UNITED STATES  
NUCLEAR REGULATORY COMMISSION  
WASHINGTON, D.C. 20555-0001

# FAILURE TIME EVALUATION

Figure 24 Variation of time to failure as a function of initial crack length, for the base case of 318°C, 95/50, crack growth rate.

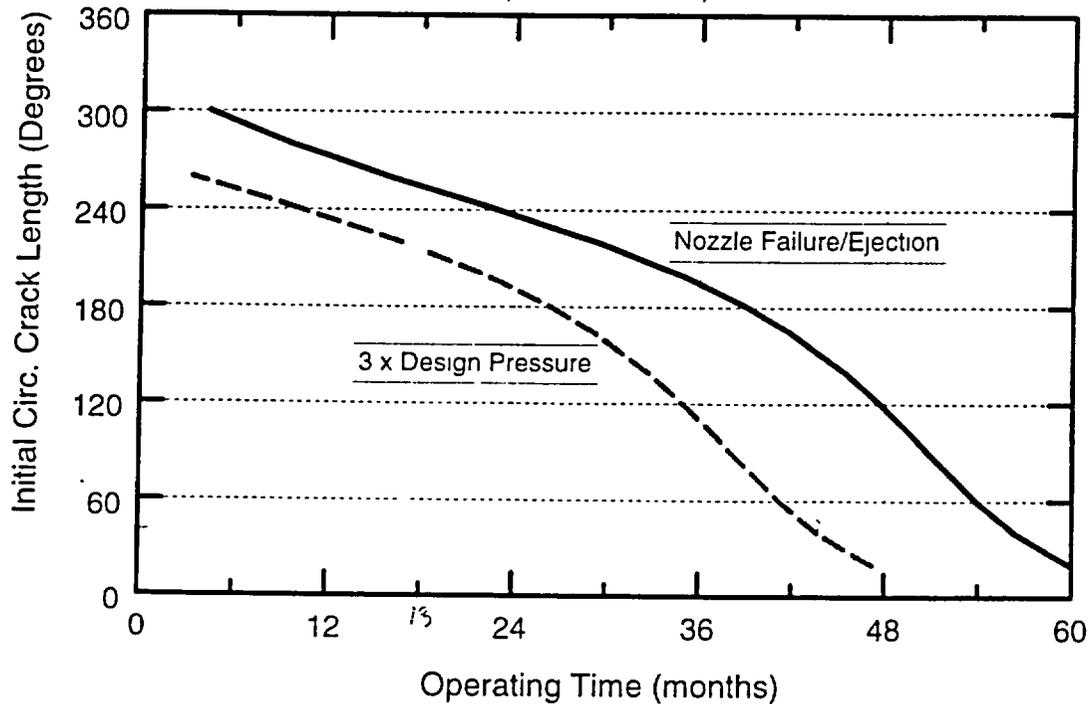
no credit for pictures  
1996 — 9490 inspected

no credit for 28 inspections from  
1998 — 7290 pictures

2000 — 6590  
no credit for  
meaningful inspection from pictures

1996 : 5 3/4 yrs = 69 months

Conclusion - there should  
have been a failure by  
now.

1998: 3 3/4 yrs = 45 months

2370 Uninspected.  
Original crack length - 450  
to get to 3x in 45  
months

2000: 19 months  
3590 uninspected, Original flaw size - 21  
to get to 3x in 19 months
